CONWAY
HISTORIC DISTRICT COMMISSION

CONWAY HISTORIC DISTRICT COMMISSION MEETING

1A FIRST BAPTIST CHURCH PAVILION + DUMPSTER ENCLOSURE - NW CORNER SCOTT & ASH STREETS

OLD CONWAY DESIGN OVERLAY DISTRICT CERTIFICATE OF APPROPRIATENESS REVIEW

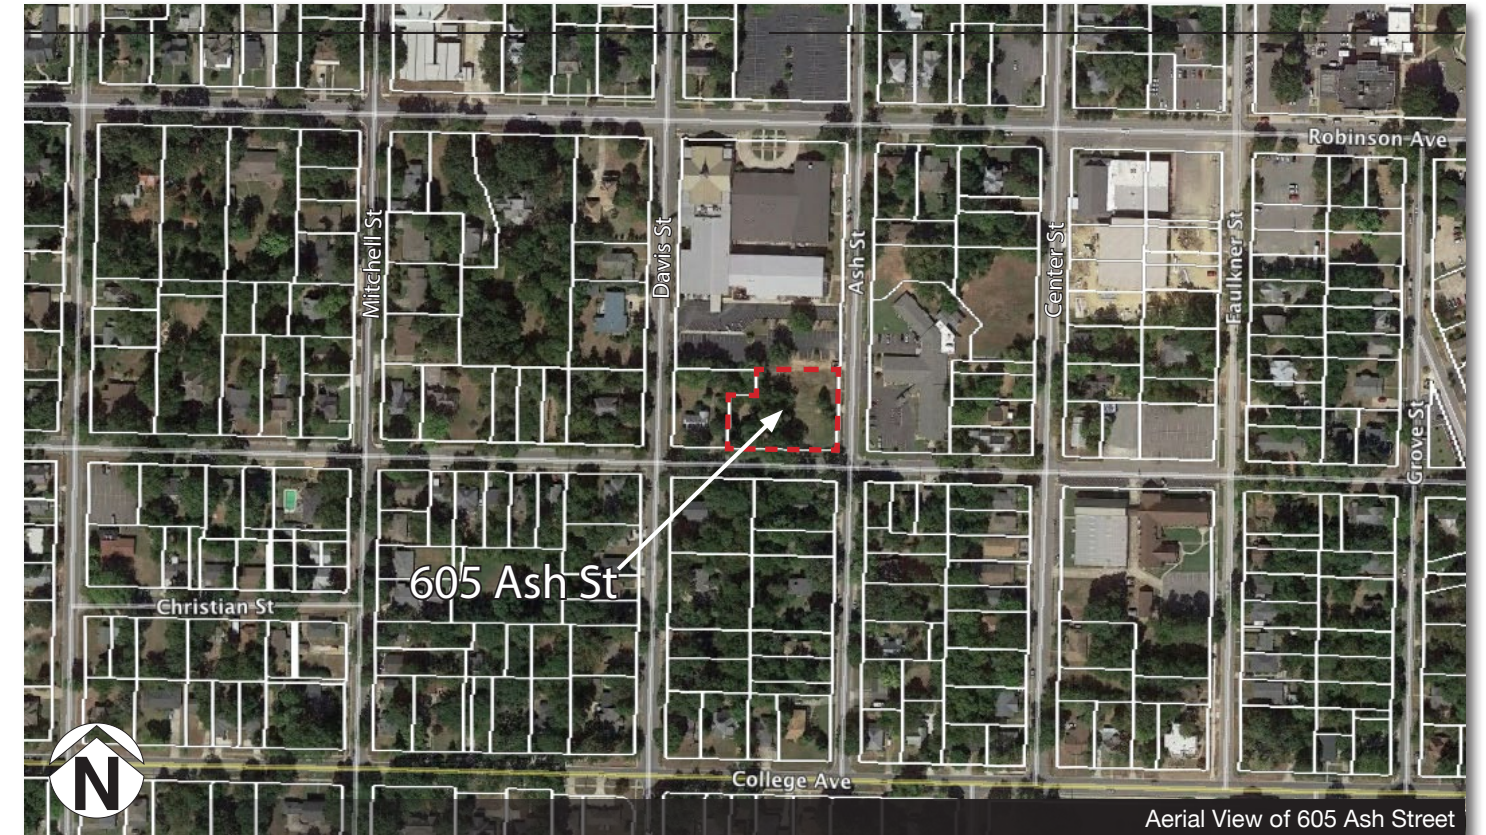
Fences. An 8 foot privacy fence is shown on the west side along a residence's property line. A decorative metal fence is shown around the other 3 sides of the park perimeter. The applicant can supply additional information concerning the fence design at the HDC meeting.

Tree preservation. The site plan shows several significant trees. No trees seem to be affected by this proposal.

1. The pavilion and dumpster enclosure shall be constructed as shown in submitted plans.
2. Fencing shall be an 8 foot wooden privacy fence on the west boundary and decorative metal fence around the remaining perimeter as shown on submitted plans.
3. Dumpster enclosure must have Conway Sanitation Department approval.
4. Gable siding material shall be _____.
5. A 4-foot sidewalk should be constructed along Scott Street.

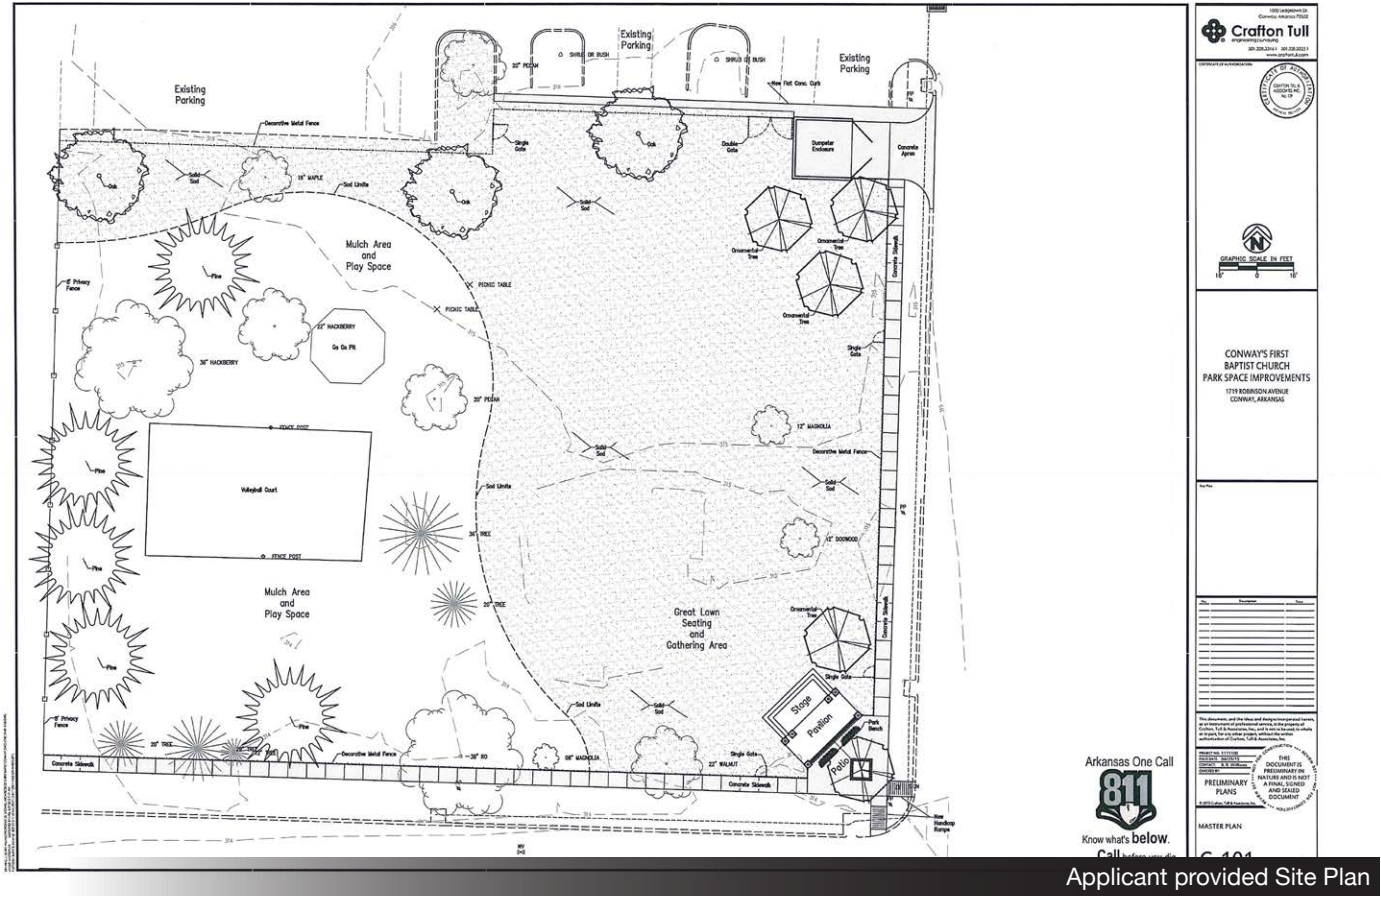
Complexity of form. The level of detailing and breaks in wall planes of a structure. The residence has appropriate detailing accomplished with wide window and door trim. The pavilion is simple in overall form, but contains detailing that relates to traditional area structures. The dumpster enclosure is utilitarian in nature, but offers some detailing through brick with a rowlock (sideways brick) detail on top.

Style. The style should compliment the existing and area structures. The pavilion has elements native to the area such as low porch columns, gables, open rafter tails, and a dormer. The pavilion also has modern hints of classic National Park Service "parkitecture". The dumpster enclosure is utilitarian.

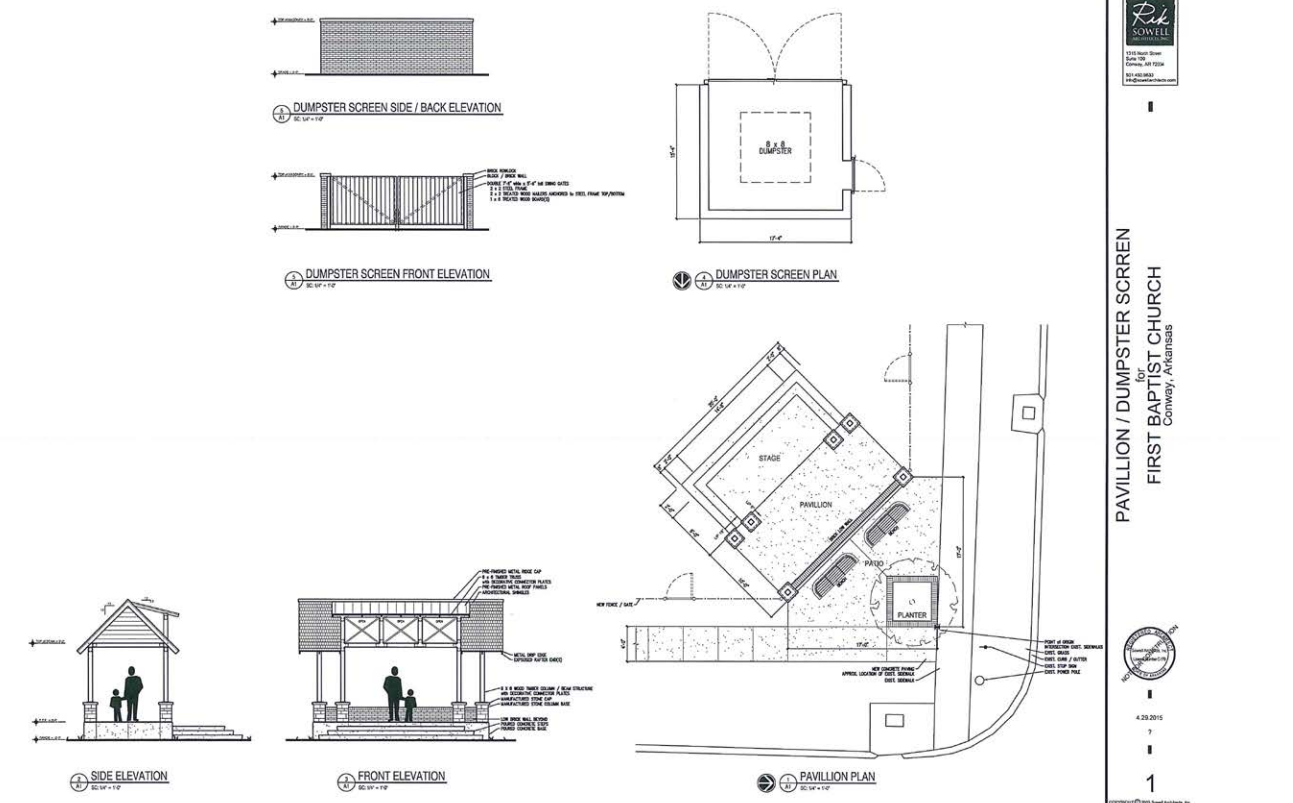
Architectural Details, Siding, and Bricks. Eaves, brackets, dentils, cornices, molding, columns, trim, etc. The pavilion has traditional detailing provided through varying materials. The open rafter tailed roof has asphalt shingles and metal roof dormer. Columns and framing are wood. Low stone bases support the wooden columns. A low brick wall defines the street facing façade and provides a “back” to 2 benches. These features add traditional detailing. The type of gable siding material is not specified. Fiber cement siding is preferred. The dumpster enclosure is brick with a brick rowlock cap.

Roof. An asphalt roof with metal roof dormer is shown.

Decks/Plaza Space. The area to the rear of the pavilion is a small concrete stage. In front of the pavilion is a concrete plaza area with a tree planter.

Proposed addition with brick

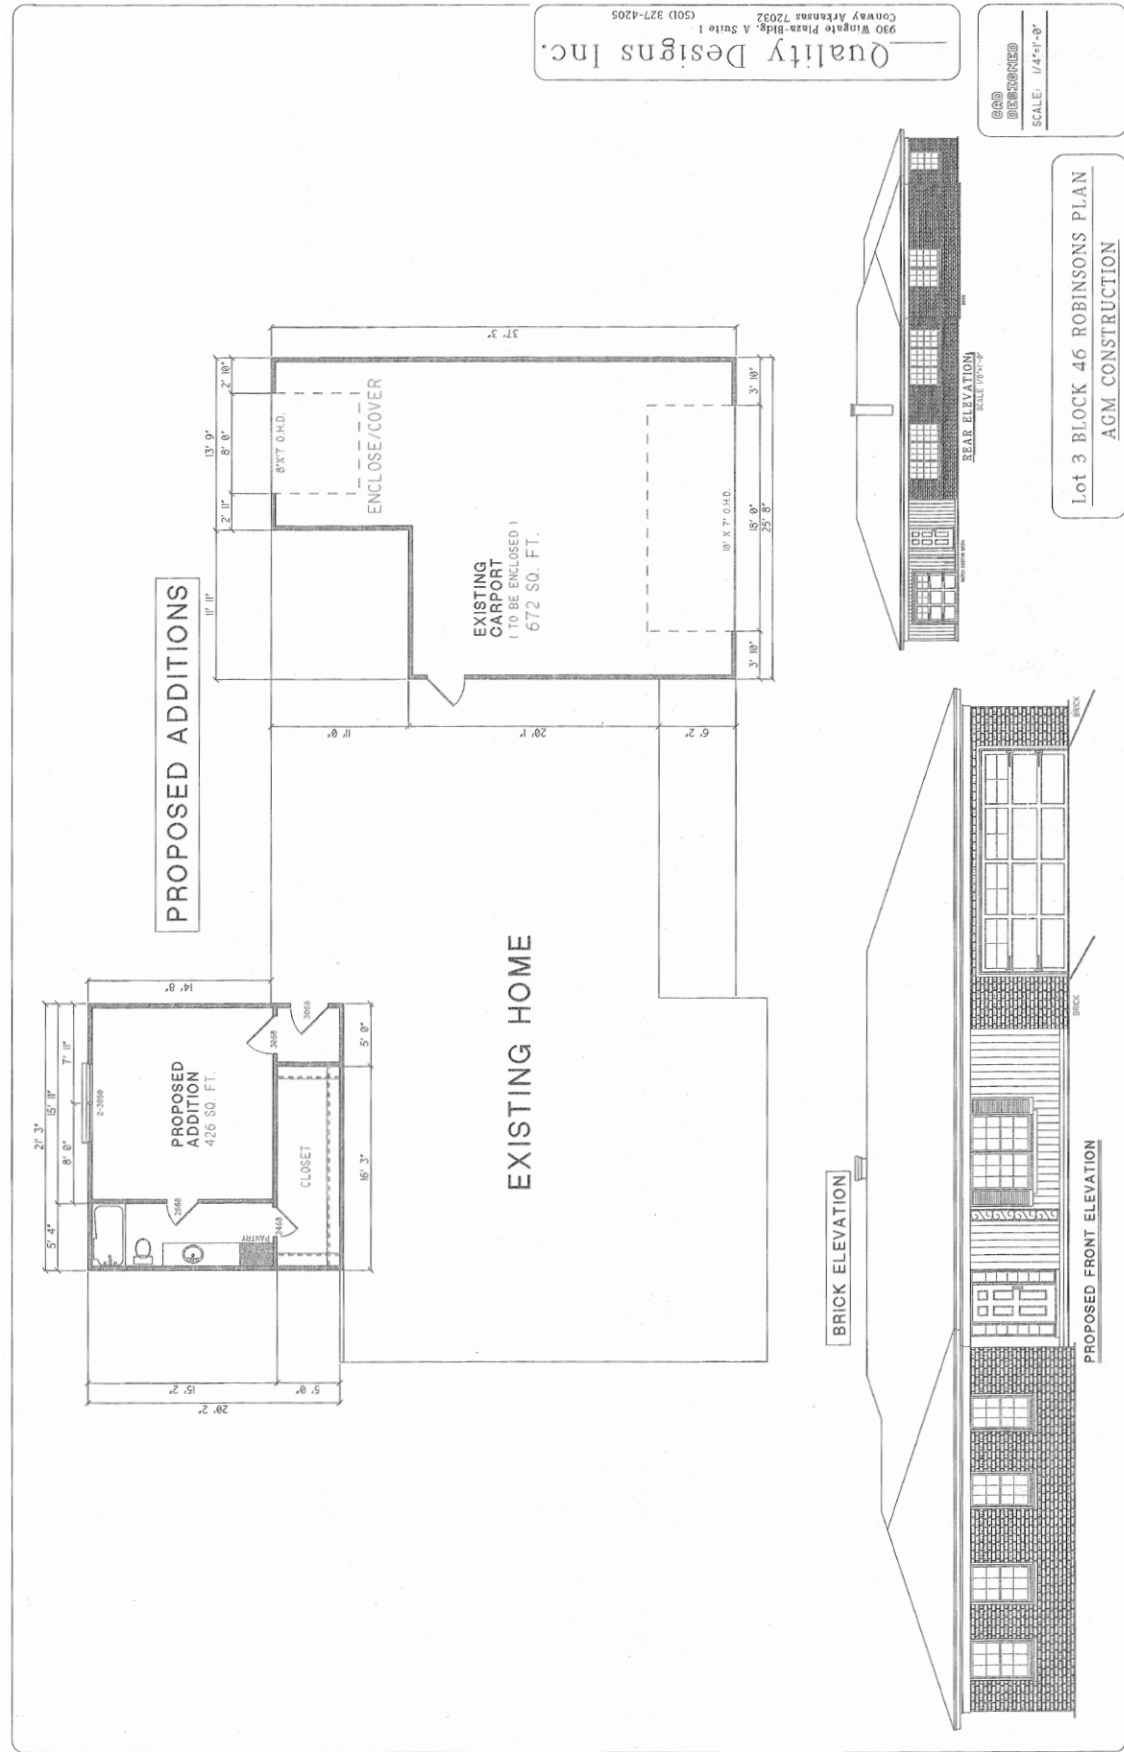
Architectural Details, Siding, and Bricks. Eaves, brackets, dentils, cornices, molding, columns, trim, etc. The existing residence has minimal details; mainly changes in materials. The applicant has submitted two drawings; one with the carport and addition with matching vertical siding or brick siding. Either material would fit the structure's style. Brick would provide a nice "book end" matching the enclosed garage to the existing east side brick. Brick would also be more durable.

1. The remodel and addition shall be constructed as shown in submitted plans with either brick or vertical wood siding or a combination of the materials.
2. Siding materials should be matched as closely as possible.
3. Asphalt shingles should match existing roofing as closely as possible, unless the entire roof is replaced with new asphalt shingles.

Applicant provided sketch of proposed addition

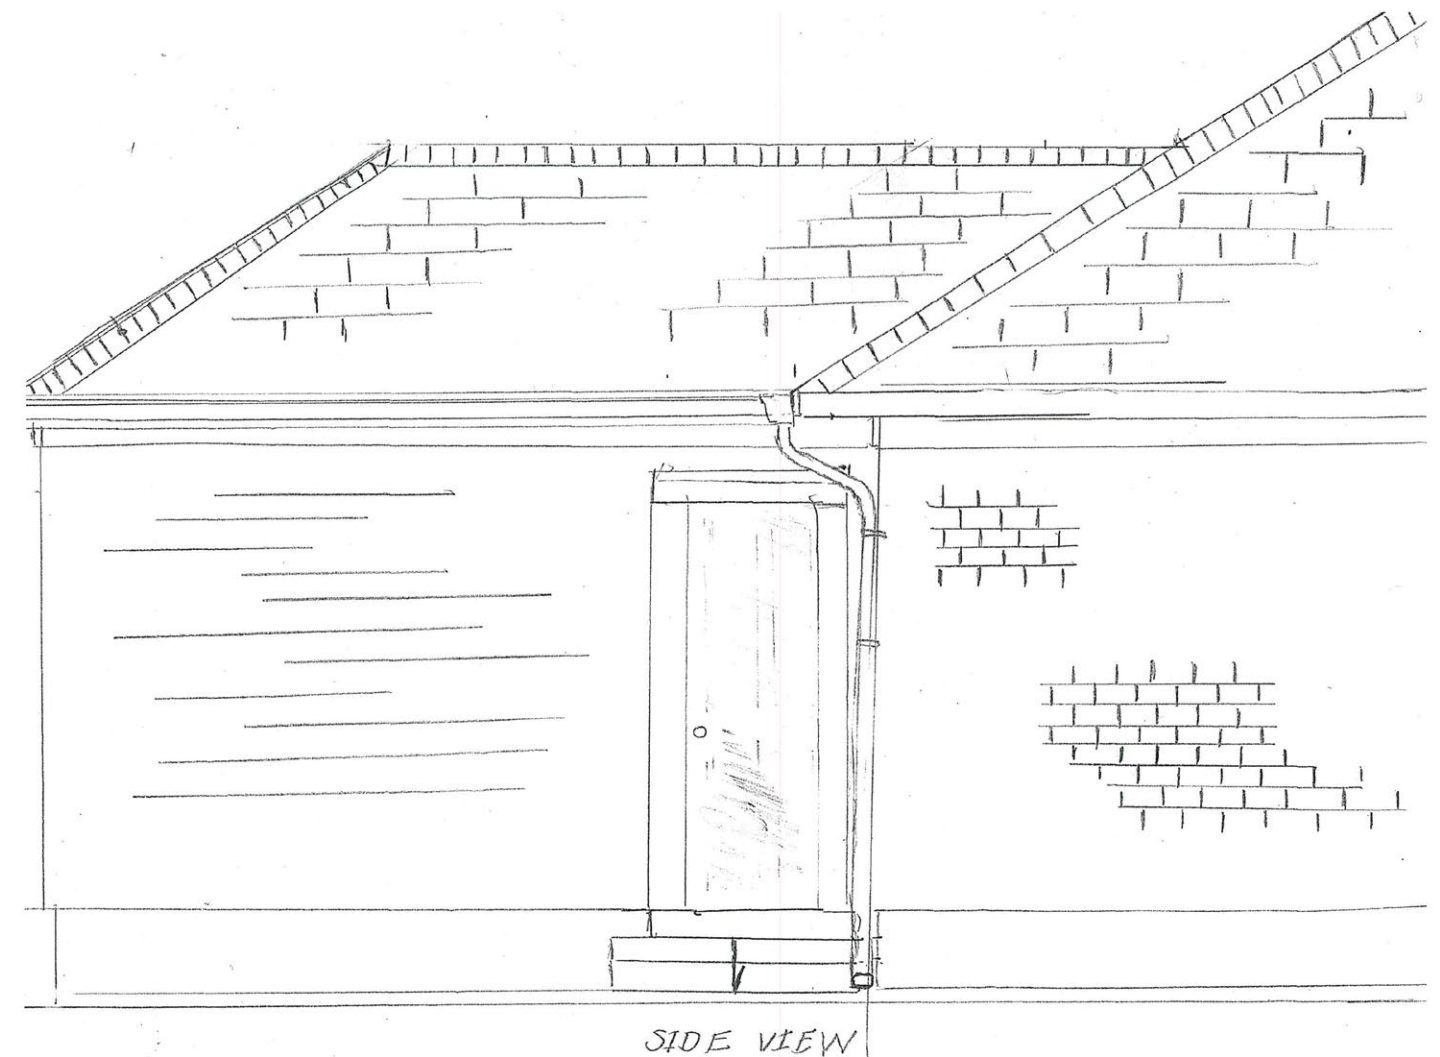
Facade, wall area, rhythm. Facades shall be compatible with surrounding historic structures in proportion of wall to opening area. The submitted north elevation shows a new door and no windows. The applicant can provide more information concerning windows and doors at the HDC meeting.

Doors and windows. As stated, a new door is planned for the north side of the addition. The applicant can give additional information at the meeting concerning any new windows. The south side of the addition will largely be out of public view from Washington. The most visible sides will be the north and east sides, viewable from Fleming.

Architectural Details, Siding, and Bricks. Eaves, brackets, dentils, cornices, molding, columns, trim, etc. The existing structure is a modified brick ranch residence without much detailing. The enclosed carport area was resided with shingle styled vinyl siding. The concrete base of the ramp and foundation was covered with rock veneer. To the rear, the former utility rooms were covered with vinyl lap siding. The new addition is proposed to be sided with matching vinyl lap siding.

1. The addition shall be constructed as shown in submitted plans with vinyl lap siding matching existing vinyl lap siding.
2. Windows? _____ additional window(s) shall be added to the north and/or east elevation(s).
3. Asphalt shingles should match existing roofing as closely as possible.
